JEPPESEN®
Airport Moving Map Alert

Subject: **Zurich, Switzerland**
Zurich (LSZH)
Cycle 2611

Apron I and TWYs F, Inner, Link 3 layout incorrect

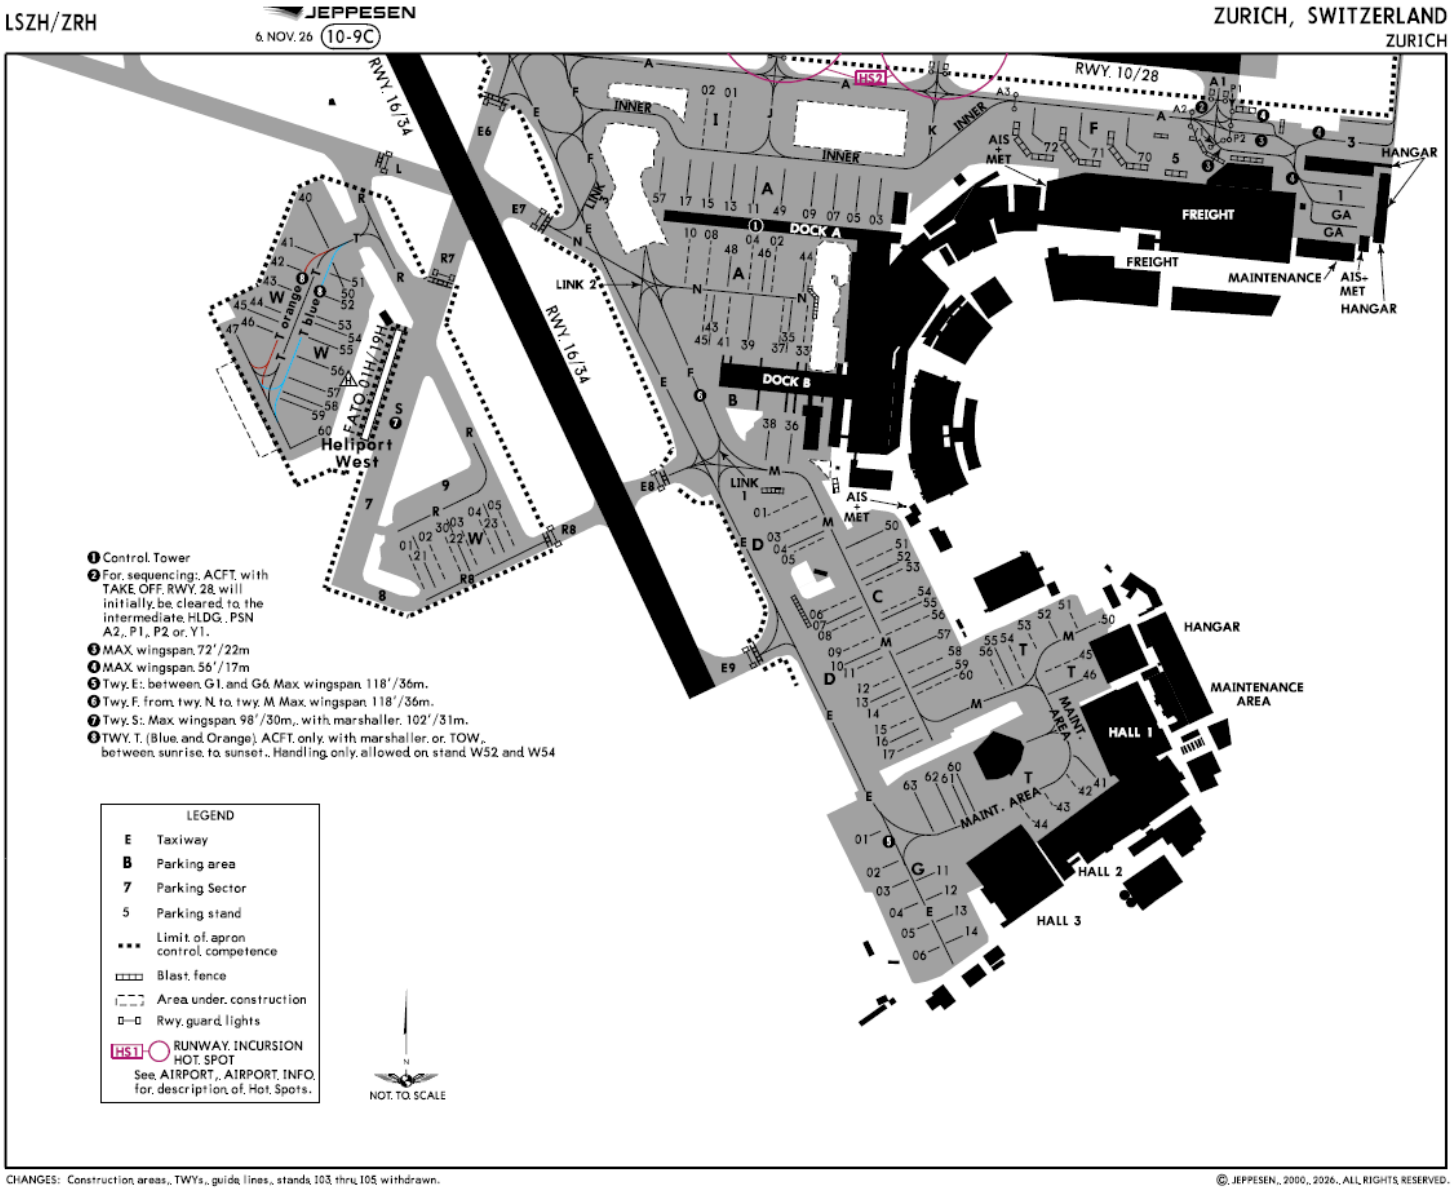
Jeppesen Airport Moving Map and A816 formatted data for cycle 2611, effective 29 October 2026, contain incorrect data for Zurich; Zurich, Switzerland (LSZH). Switzerland AIP AMDT 011/2026, effective 29 October 2026 was received after 2611 AIRAC cycle data processing due date.

As a result, the following changes are not reflected in cycle 2611 data:

- TWY Inner (between TWY F and Parking Stand I02) is shifted north
- TWY F and Link 3 are shifted southeast
- TWY F (between TWY Link 3 and TWY N) is closed
- Parking Stands I03-I05 are removed
- Construction Area (between TWY Link 3 and Parking Stand A57) is added
- Construction Area (between TWY F and Parking Stand I02) is added
- TWY (east of Stand T54) is labeled TWY M

Revised data will appear in Jeppesen Airport Moving Map and A816 formatted data for cycle 2612, effective 26 November 2026. Until then this Alert will be posted on the Jeppesen Web site: Notices and Alerts. Please refer to the local NOTAMs for valid information and Zurich, Swizterland (LSZH) 10-9C chart dated 6 NOV 26 for valid information.
